Submitted By	Company	Date Submitted
Brian Theaker	NRG Energy, Inc.	March 20, 2015

NRG Energy, Inc. (“NRG”) submits the following comments on the CAISO’s March 5, 2015 *Issue Paper and Straw Proposal: Reactive Power Requirements for Asynchronous Resources* (“IPSP”).

2015 policy development base roadmap

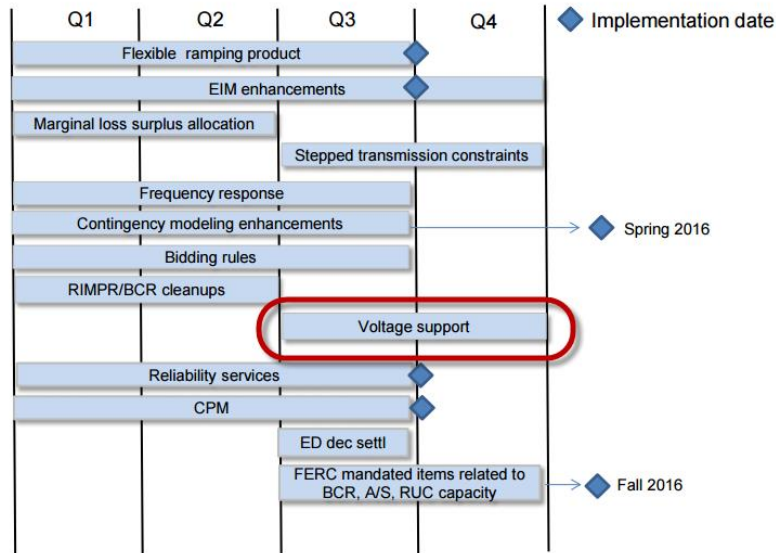
On February 5, the CAISO presented to its Board of Governors a "2015 policy development base roadmap" that indicated the CAISO would finally deal with the issue of reactive power/voltage support compensation in Q3/Q4 2015:

The issue of the CAISO providing compensation for providing reactive power should be dealt with before the issue of imposing a uniform reactive power control requirement on asynchronous generating resources is finalized. NRG urges the CAISO to defer this stakeholder process seeking to impose uniform reactive power control requirements on asynchronous generators until the issue of providing suitable compensation for reactive power support has been resolved. If the CAISO moves forward with this asynchronous reactive power initiative before launching the voltage support procurement stakeholder process, it must commit to launching that initiative by the schedule listed in the Board briefing.
